I am writing to inform all that are involved my findings with getting storm utilities to the former Wettsteins building now owned by Gundersen Health System. Previously, we wanted to use the alley as a route to get a storm sewer connection in State St. and travel north extending two laterals into the building to pick up clear water discharge in the building and rain load from roofs. With some recent investigation the contractors have found some un-marked utilities and un-foreseen issues with using the alley as a route. My intension for using the alley was in hopes to make one city connection and close down one street (State) to do this work. With the alley Un-usable for us, we will have no choice but to utilize storm sewer in Vine St. for the next phases of construction. Vine St. also has a 12" storm sewer, and we have options for a route for the next phases to continue to remedy the lack of storm utilities to this building. We would still need to get a storm connection for the southern 1/3 of the remodeled portion of the building in State St. An 8" storm connection would need to be done now to alleviate the Clearwater waste needs of the current remodeled space to the south. Anothe

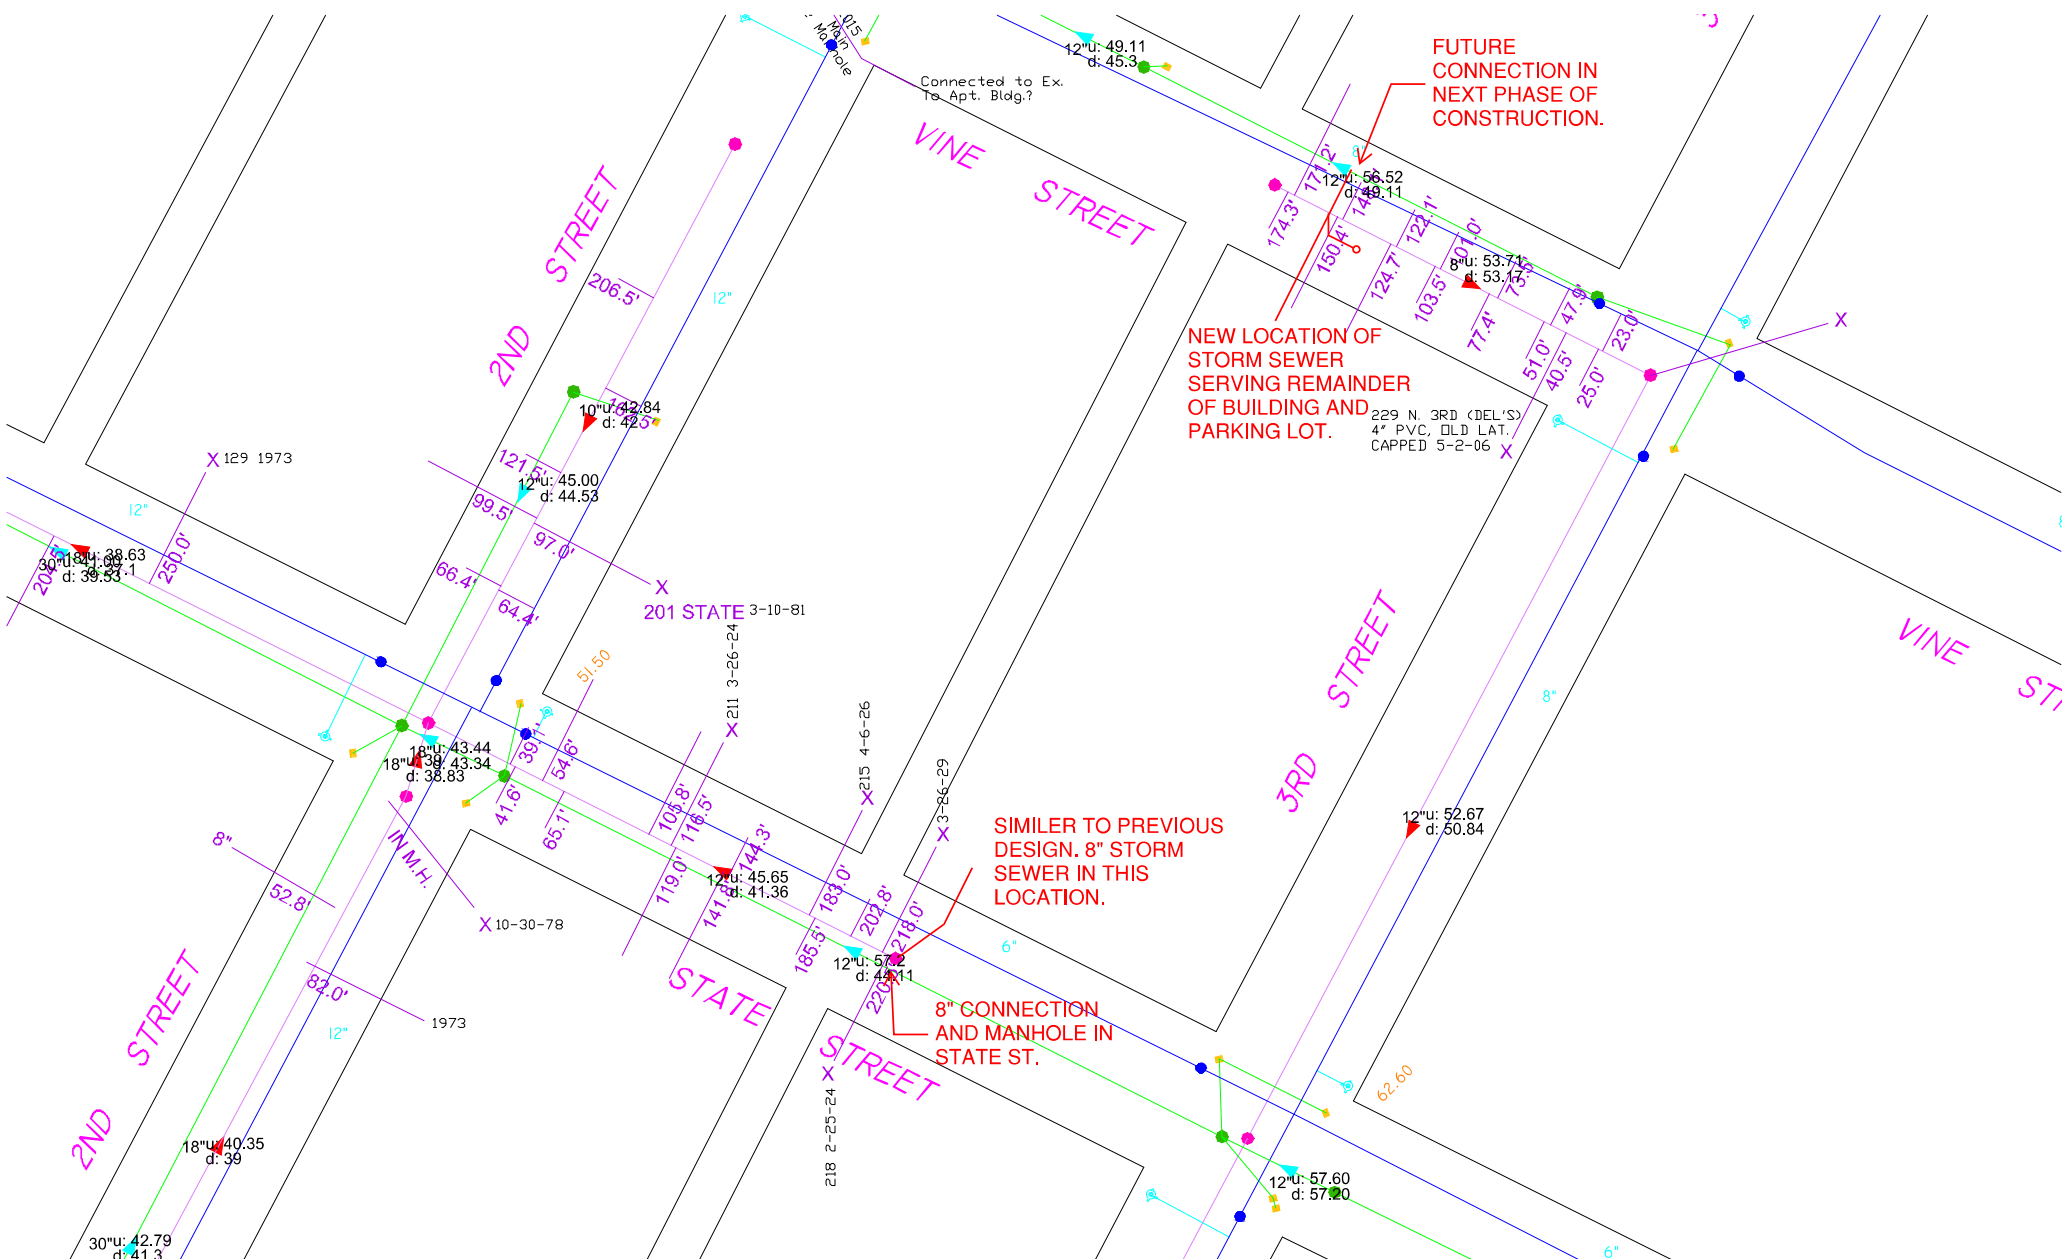
FUTURE CONNECTION IN NEXT PHASE OF CONSTRUCTION.

NEW LOCATION OF STORM SEWER SERVING REMAINDER OF BUILDING AND PARKING LOT.

SIMILAR TO PREVIOUS DESIGN. 8" STORM SEWER IN THIS LOCATION.

8" CONNECTION AND MANHOLE IN STATE ST.

Connected to Ex. To Apt. Bldg.?
